From: [Visser, Mark](#)
To: [Holt, Leigh](#)
Subject: Fw: DFO# 24-HPAC-00422; Road Flood Response, Cowichan Bay, Cowichan Bay; Information request
Date: May 9, 2025 10:04:40 AM
Attachments: [image001.png](#)
[24-HPAC-00422 SIR Response WIP.pdf](#)
[2024-07-02 Mini Rd for DFO.pdf](#)
[Outlook-1lbq50cy.png](#)

Subject: DFO# 24-HPAC-00422; Road Flood Response, Cowichan Bay, Cowichan Bay; Information request

DRAINAGE PROFILE
 MINI ROAD SLIDE, COWICHAN BAY
 SLOPE FAILURE REMEDIATION AND DRAINAGE IMPROVEMENTS

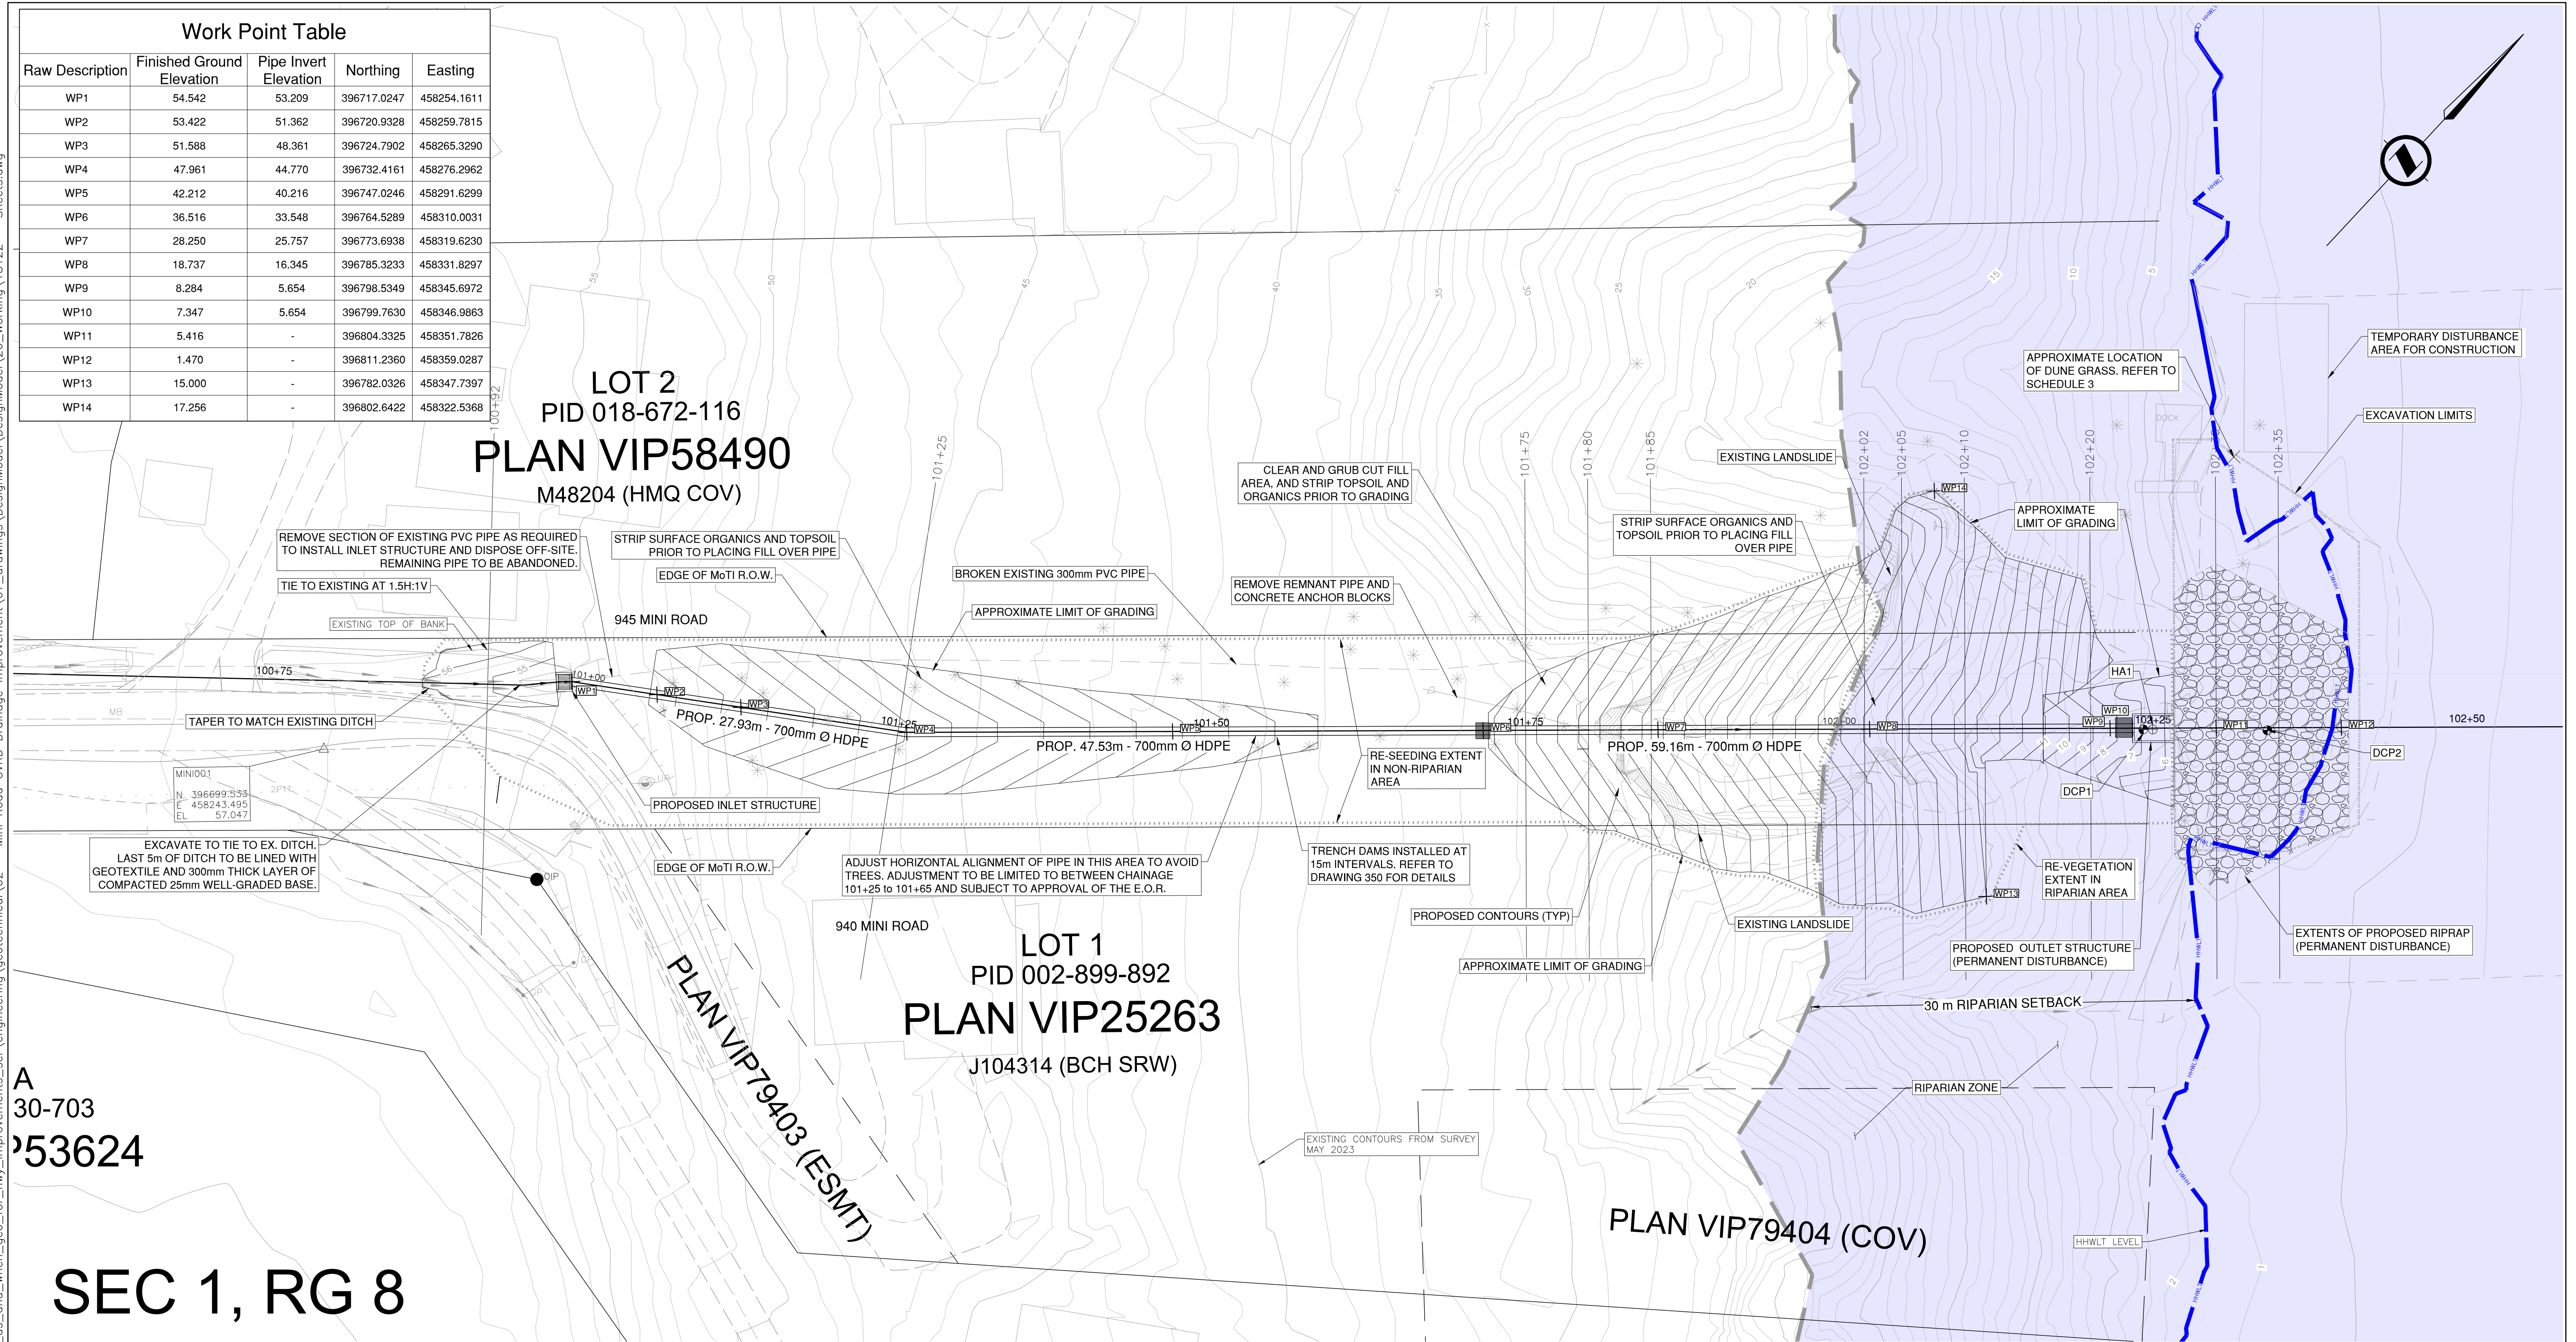
- An EMP is referenced within the OEA but has not been supplied. Please provide this document for our review.
- A description of the 79.7 m² temporary intertidal work area including:

5. Attached is the most up to date plan and profile drawing to clarify the Project Footprints. Below is an image of the Project footprint breakdown:

LOCATION	AREA (m ²)
RIPRAP BELOW HHWLT	128.5
PERMANENT VEGETATION DISTURBANCE WITHIN 30m OF HHWLT	13.97
TEMPORARY DISTURBANCE AREA IN RIPARIAN AREA	807.8
TEMPORARY DISTURBANCE AREA IN NON-RIPARIAN AREA	1892.2
TEMPORARY DISTURBANCE AREA FOR CONSTRUCTION (LAYDOWN AREA)	79.7
